Reference: Advanced Business Sciences Application, Ref # 7183
FCC ID: OAM170102
Confirmation #EA93180

Reference FCC ID: QAM178102

Applicant: Advanced Business Sciences Inc

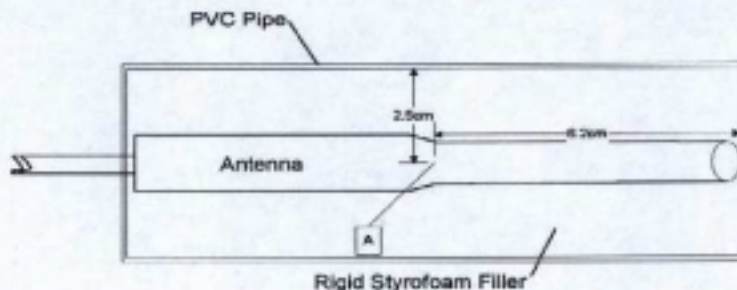
This is a body worn device. Photos are missing from file.

Data shows .3 W conducted, .24 ERP and 121.1 dBu/M field strength.
